**Hennepin County Transportation Department**

**ADDENDUM**

**ADDENDUM NO. 4**

**CSAH 101; C.P. 9917  
S.A.P. 027-701-019; 027-603-057**

SHEET  
 46R2  
 571

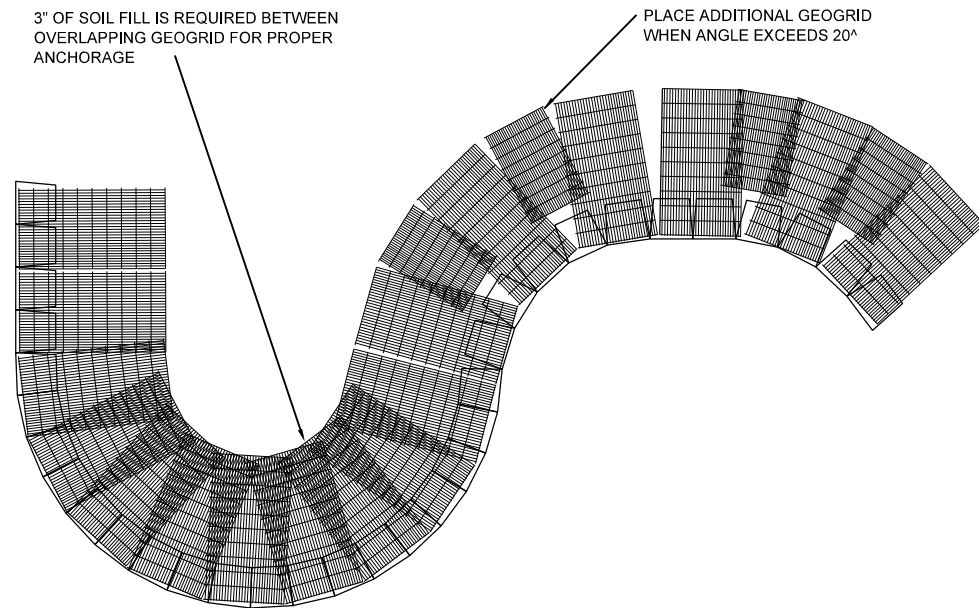
1. Plan Sheet No. 46R1 CONSTRUCTION NOTES & STANDARD PLATES – **Remove and Replace** with attached Sheet 46R2. 9350A removed from standard plate list.
2. Plan Sheet No. 285R RETAINING WALL PLAN – MODULAR BLOCK – **Remove and Replace** with attached Sheet 285R1. Notes revised.

⚠ NOTE 7 REVISED.

⚠ NOTE 5 REVISED.

⚠ 9350A REMOVED FROM STANDARD PLATES LIST

**SHEET**  
**285R1**  
 571

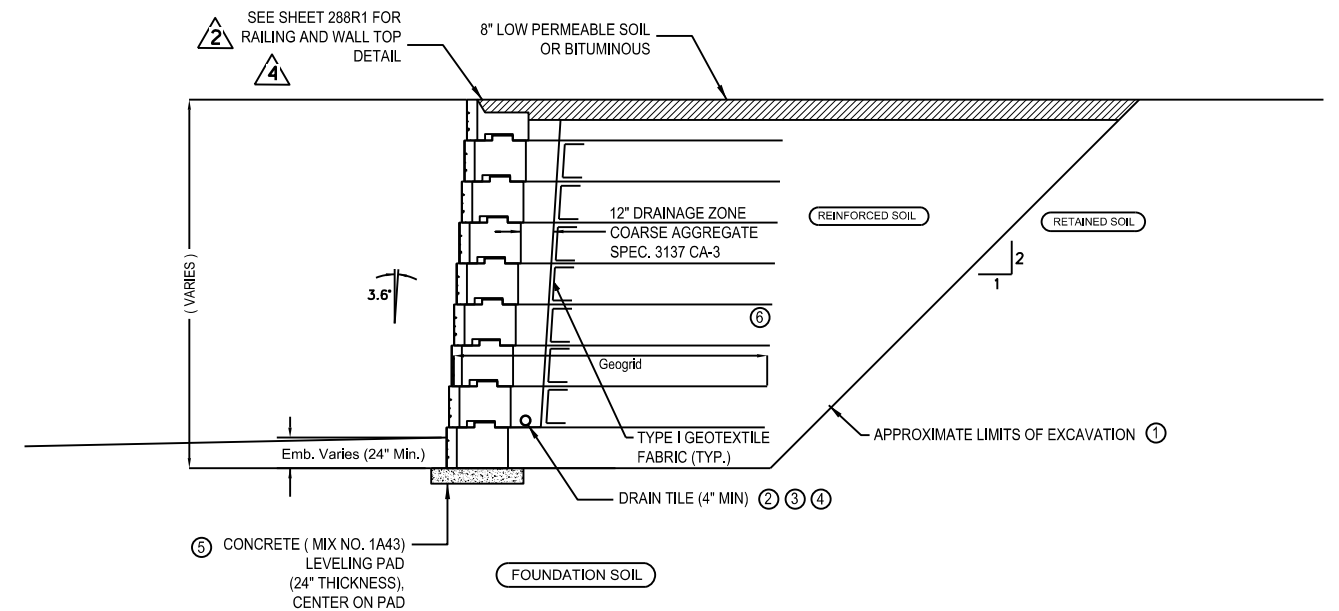
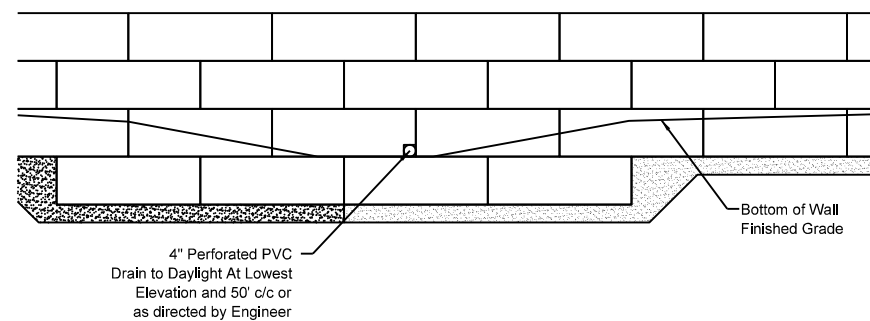
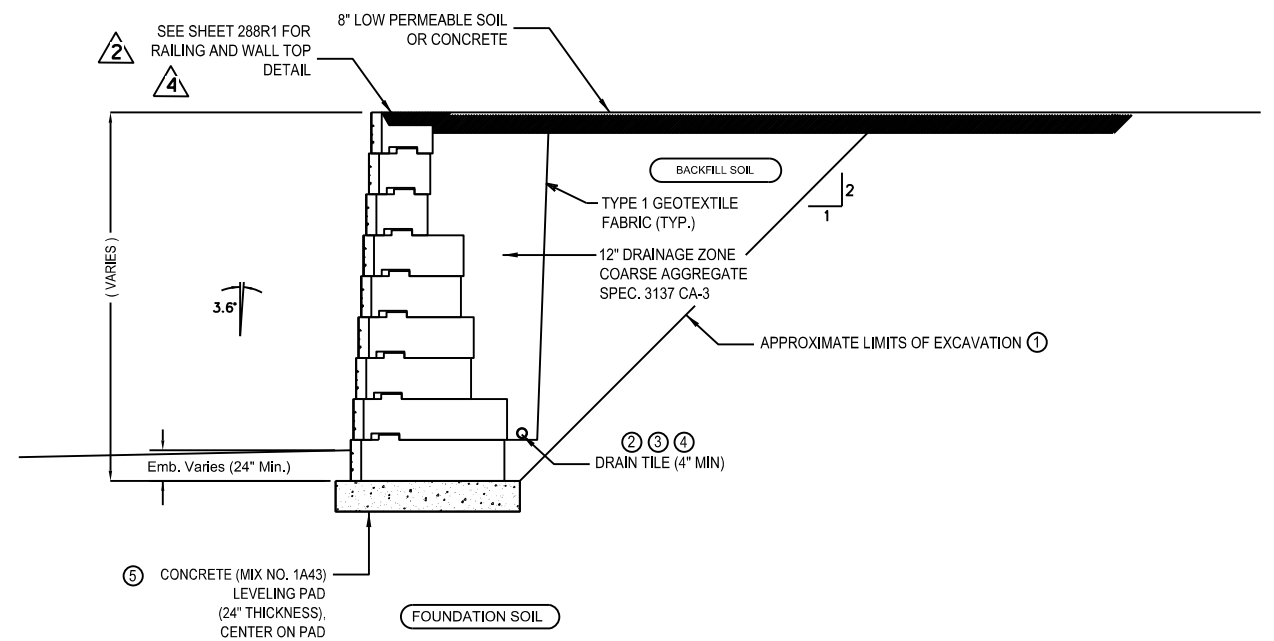
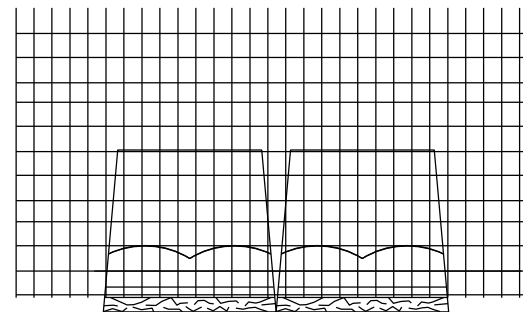
- ② NOTE ADDED REFERENCING WALL TOP DETAIL
- ④ NOTE REVISED

288R1

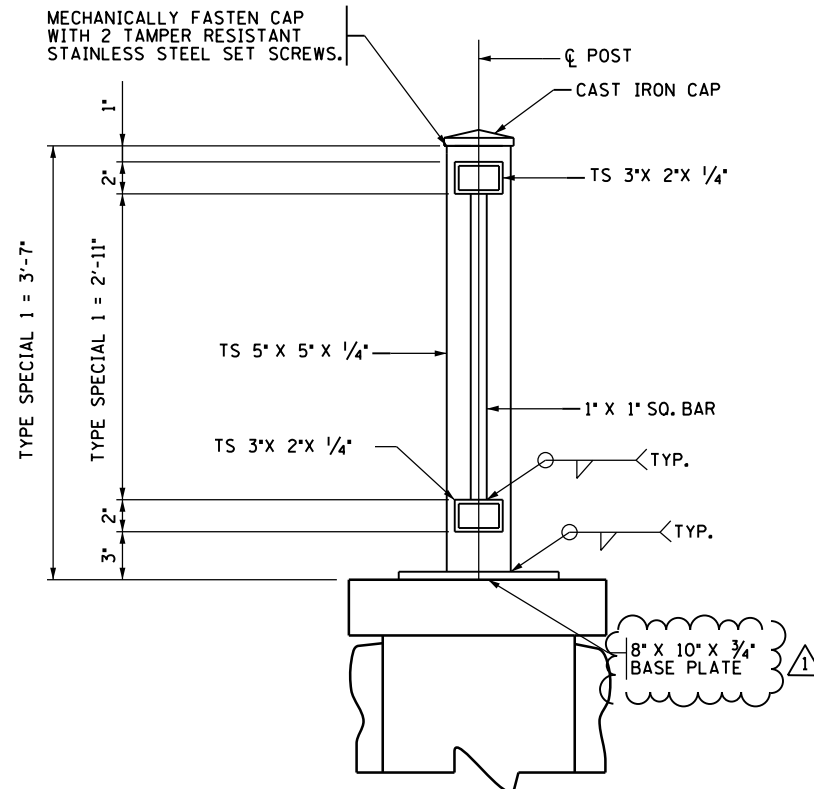
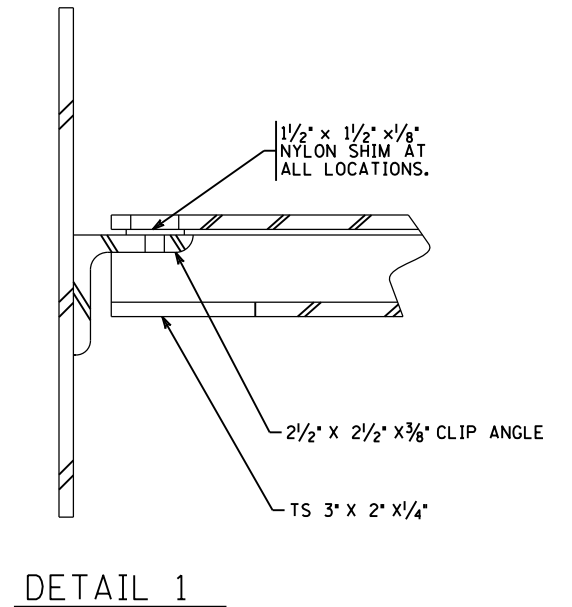
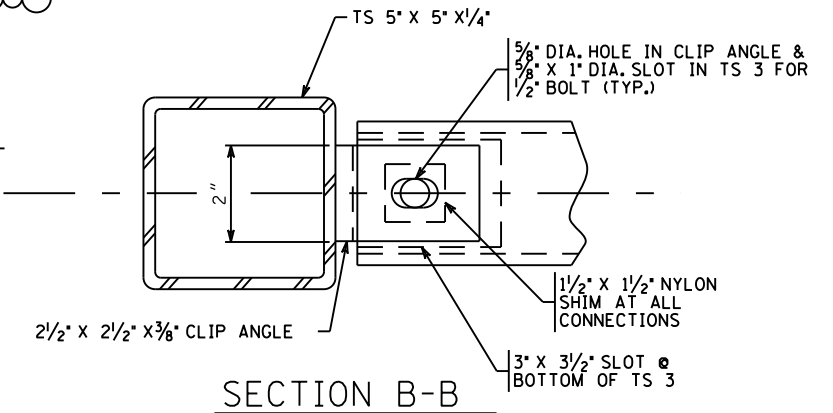
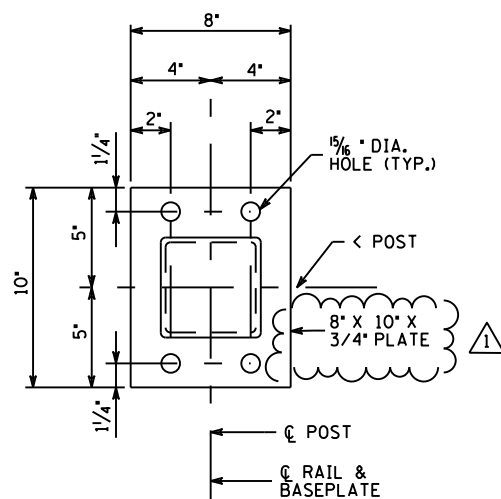
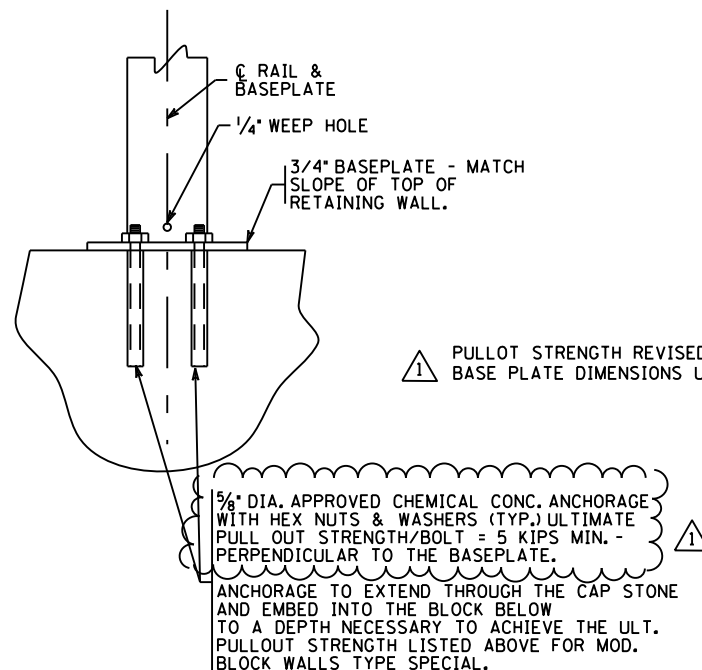
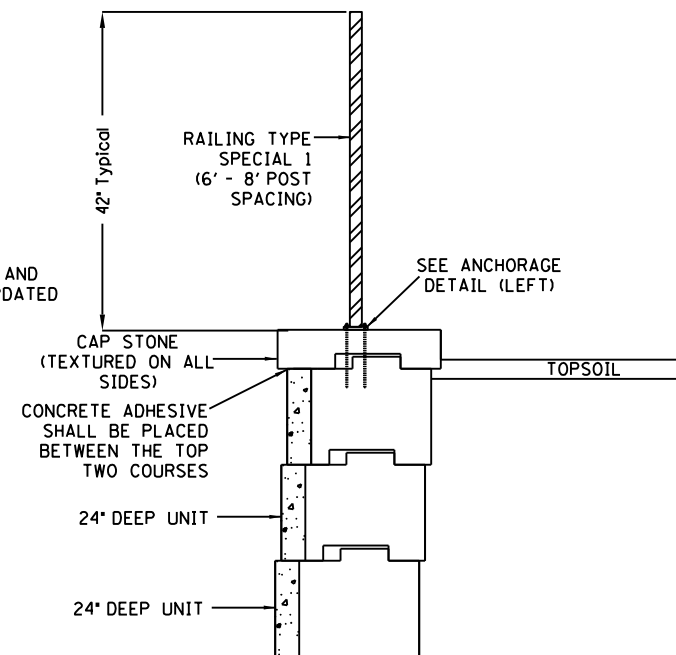
3. Plan Sheet No. 288R RETAINING WALL PLAN – RAILING DETAIL – **Remove and Replace** with attached Sheet 288R1. Last general note revised.
4. Plan Sheet No. M4 INTERCEPTOR 7016 HWY 101 CROSSING DETAILS – **Remove and Replace** with attached Sheet M4R. Detail 3-M4R WATERTIGHT MH LID revised.

- FOR RAILING ANCHORAGE REQUIREMENTS SEE THE SPECIAL PROVISIONS.
  - FOR RAIL COATING SEE THE SPECIAL PROVISIONS.
- ⚠️ CAP STONE MUST BE ADHERED TO THE BLOCK BENEATH IT. FRONT AND BACK BLOCK FACES THAT ARE EXPOSED MUST BE TEXTURED.
